Westinghouse
Electric Corporation

DPC/NRC1251
NSD-NRC-98-5565

SUBJECT: CONTAINMENT COATINGS INFORMATION

Attached are responses to questions related to the use of nonsafety-related coatings inside containment and on the exterior of the containment shell. These informal questions were provided in a telecopy on January 27, 1998, and subsequently documented in a letter dated January 30, 1998. These responses are provided to support our meeting on February 11, 1998, to discuss paint and other coatings in the AP600 containment.

Figure 1 - AP600 Coating Debris Settling

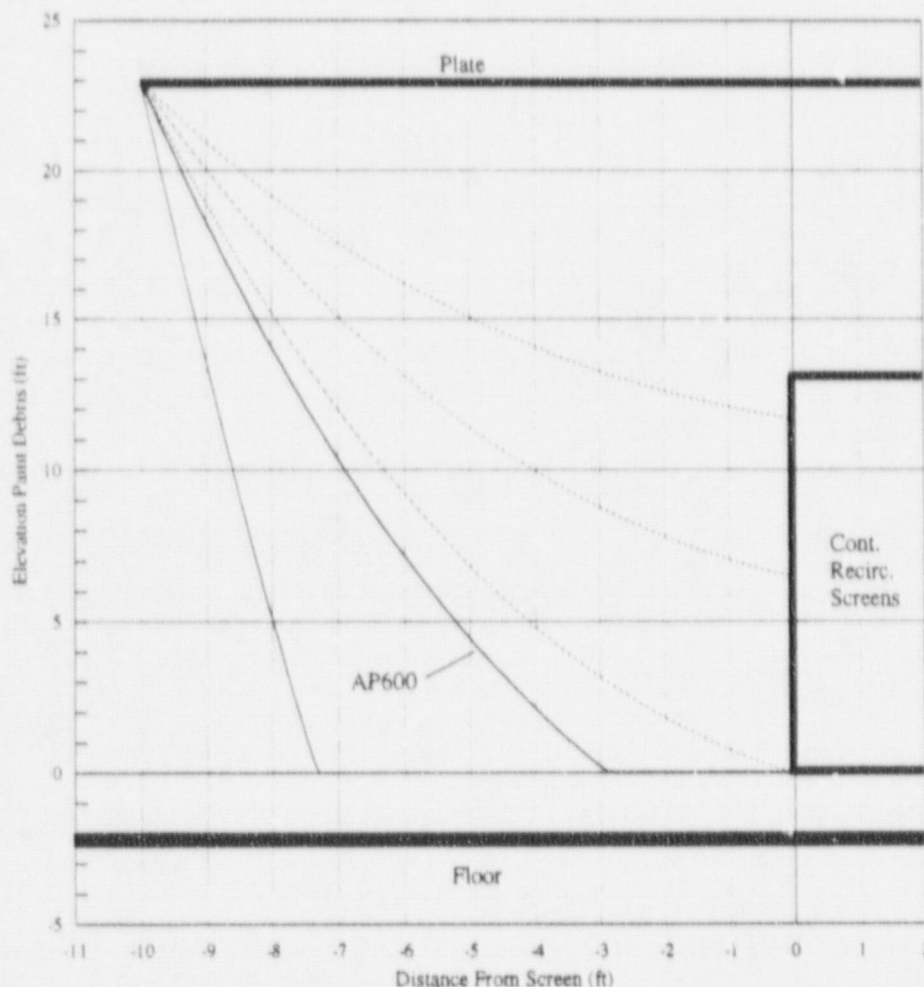
Westinghouse has not provided a quantitative or experimental bases which demonstrate why failure of the containment coatings will not prevent functioning of the engineering safety features. Calculations are required to determine if failure of the coatings will result in blockage of strainers. The analysis must be reviewed by the NRC staff since there is uncertainty in the calculations. Even if Westinghouse were to perform a transport analysis, the staff is not likely to accept it without additional experimental validation.

Figure 1 shows the results of these calculations. This figure shows that coating debris entering the post accident flood up water at the edge of the protective plate will settle to an elevation that is below the bottom of the screens after drifting about 7 feet, which is at about 3 feet away from the screen. This calculation includes significant conservatisms, including the lightest/smallest coating debris. It assumes the maximum recirculation flow of 1600 gpm, consistent with the maximum flow from one RNS pump operating unthrottled with suction taken from one screen. Another area where significant margin has been applied is in the debris settling rates. AP600 uses debris settling rates that contain a factor of 2

margin compared to the reference settling data (Reference 1) which is sufficient to account for uncertainties. Without this added margin, the coating debris settles out very quickly in about 3 feet, as shown in Figure 1.

This figure shows that the AP600 has significant margin to accommodate uncertainty in coating settling rates. The heavy solid line shows the AP600 design case, which includes a margin factor of 2.00 times the reference settling data (Reference 1). The light dashed lines represent sensitivity studies with greater margins. The margins applied were arbitrarily chosen to force the debris to settle out at the bottom of the screen (factor of 2.3), covering half of the screen (factor of 3.2) and covering 90% of the screen (factor of 4.7). Even with 90% of the screen blocked, the PXS would still be able to operate. The light solid line shows the reference settling data. All of these cases assume the maximum possible RNS flow assuming one RNS takes suction from one screen and is unthrottled (1600 gpm).
